**Report of 10 CFR 72.48 Evaluations Performed for the
NUHOMS® EOS System for the Period
06/06/19 through 01/30/20**

**REPORT OF 10 CFR 72.48 EVALUATIONS PERFORMED FOR THE
NUHOMS® EOS SYSTEM FOR THE PERIOD 06/07/19 to 01/10/20**

**Figure 1
EOS 37PTH Drain Port**

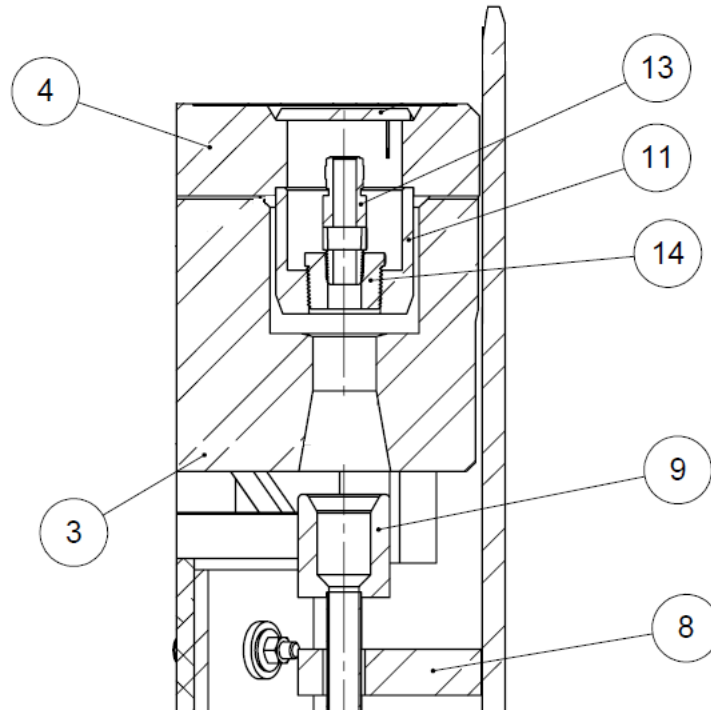
A TN nonconformance report indicated that the 1-1/4 Female National Pipe Thread (FNPT) drain port tap part 11 was not deep enough to achieve a seal with the male bushing part 14 (see Figure 1 below). The inner top cover plate had already been welded on the loaded DSC, and vacuum drying and pressure testing had been completed. The threads were repaired in place with a manual pipe tap. See Figure 1 below.

Because the vent port had already been welded, the repair operation was time limited rather than taking place under a helium purge. This aspect was determined to be an adverse effect on control of a design function described in the UFSAR, that is, the prevention of oxidation damage during loading of fuel (Reference NUREG 1536 Revision 1, Section 8.4.18).

A calculation was performed which demonstrates that assuming instantaneous replacement of the internal helium by air,

1. it would require more than 5 hours before oxidation would cause damage to the fuel,
2. at three hours of air exposure, considering the initial condition and transient based on the heat load for this DSC, the maximum cladding temperature would be 640 °F, below the 648 °F reported in UFSAR Table 4-32, and well below the 752 °F (400 °C) limit, and
3. the cladding temperature change is below the 65 °C temperature cycling limit of NUREG 1536 Revision 1

Therefore, a 3-hour time limit was established for the repair, from the time that the quick-connect fitting item 13 was removed from the drain port, to the time that at least 200 torr helium was re-introduced into the DSC.
